"DeviceNet Safety NE1A Series Safety Network Controller OPERATION MANUAL"

(Publication in July, 2009) (Catalog number Z906-E1-07)

Page 54 "Example of Connecting Two-hand Switches"

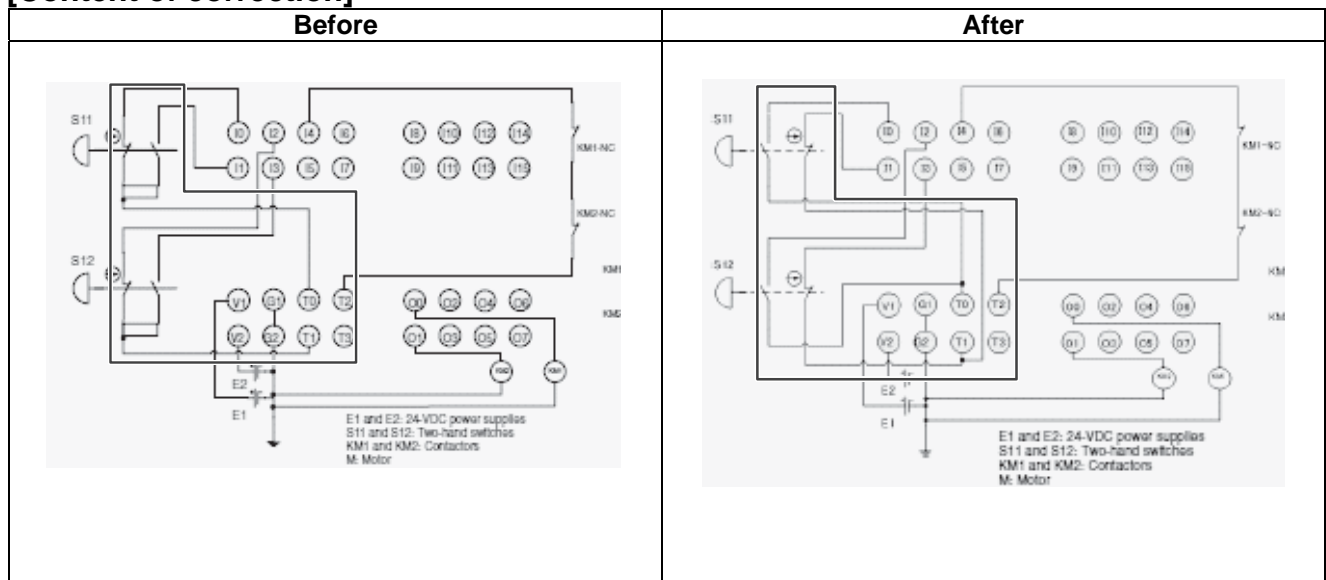
The mistake of the print and the description is found in the manual that our company issued. It apologizes.

[Content of correction]

We revise it at the time of a manual reprint on the next time. (The Revised version will be Rev.08.)

We attach the correction note about this in the existing manual until revised manual is published.
